PERMIT MODIFICATION APPROVAL

Re: Permit Modification Approval for API Number 9502281, Well #: 512893

Adjust FW and INT. Casing

Re: Modification of 095-02278, 02279, 02280, 02281

Well 512893(WEU4H4)
EQT Production
West Union
Tyler West Virgina

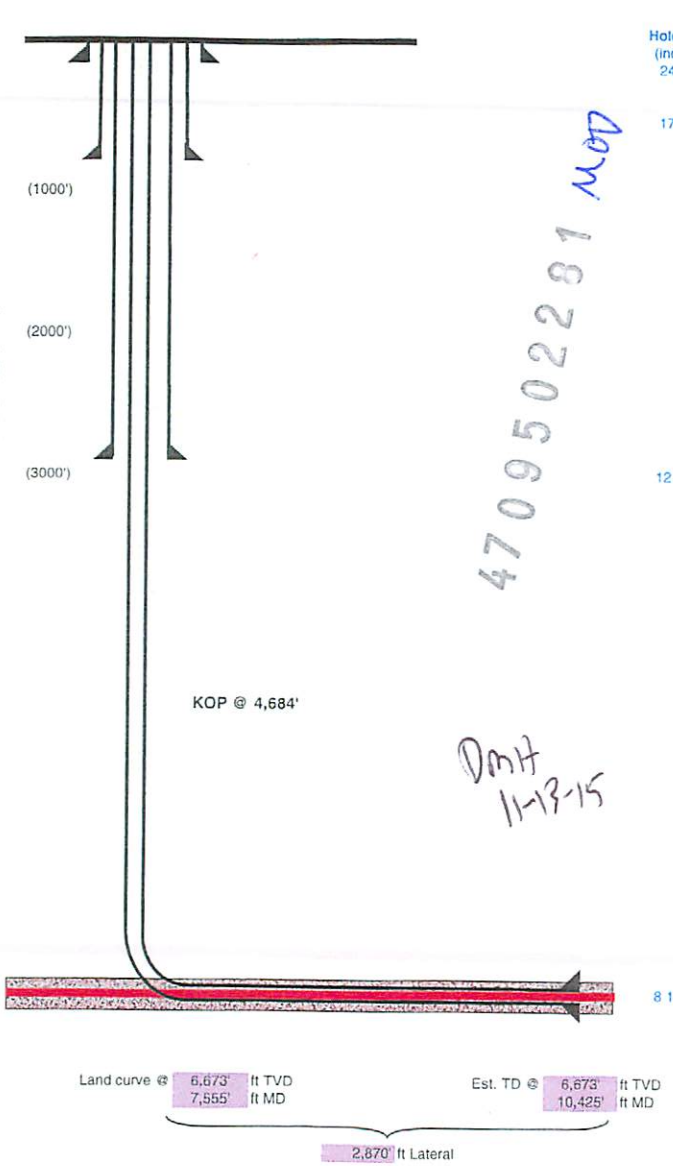
Enclosed are modifications of the above API numbers located on the WEU4 pad. EQT would like to adjust the casing on the Fresh water and Intermediate casing to match the others in for permit currently. Everything else remains the same.

EQT is requesting the 13 3/8" surface casing to be set at 750' KB, 50' below the coal at 696-700' KB. We will set the 9-5/8" intermediate string at 2865' KB, 50' below the base of the Gordon.

Hole Size (inches)	Casing Type	Size (inches)	Wt (ppf)/Grade
24	Conductor	20	81#/MC-50
17 1/2	Surface	13 3/8	54.5#/J-55
12 3/8	Intermediate	9 5/8	40#/A-500
8 1/2	Production Casing	5 1/2	20#/P-110
